# CWSP SYSTEM HARDENING FIELD SCOPING DOCUMENT

<b>PM:</b> [REDACTED]	<b>Project Name:</b> SH - BUCKS CREEK 1101 CB	
<b>Notification:</b> [REDACTED]	<b>Region:</b> Northern	<b>City:</b> Rock Creek
<b>Project Manager:</b> [REDACTED]	<b>Division:</b> North Valley	<b>County:</b> Plumas

### Routes of travel for first responders and evacuees if a fire happens:

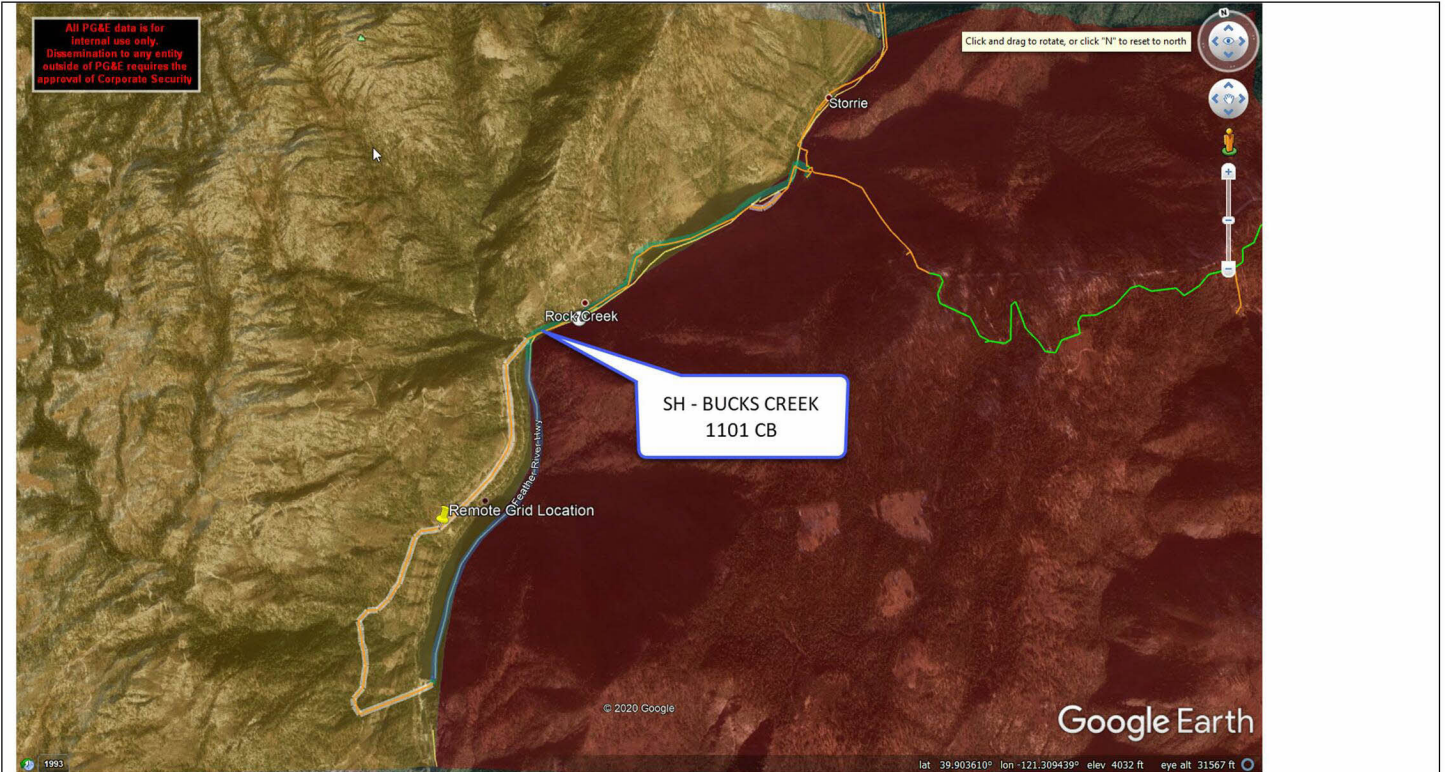
- This project crosses Highway 70 near the Bucks Creek Powerhouse and then parallels the highway for a roughly 2-mile stretch, and then runs along Storrie Rd. paralleling the Feather River on the canyon opposite side of Highway 70. Highway 70 is a main thoroughfare for ingress/egress for emergency responders and to the few residents who live in that direct area; it is also a major route for commerce both by vehicle and railroad.
- If Highway 70 was closed in this area it would make ingress and egress difficult if not impossible for responders and citizens; and, economically be a substantial hit to commerce. There are no alternative routes within the Feather River Canyon.
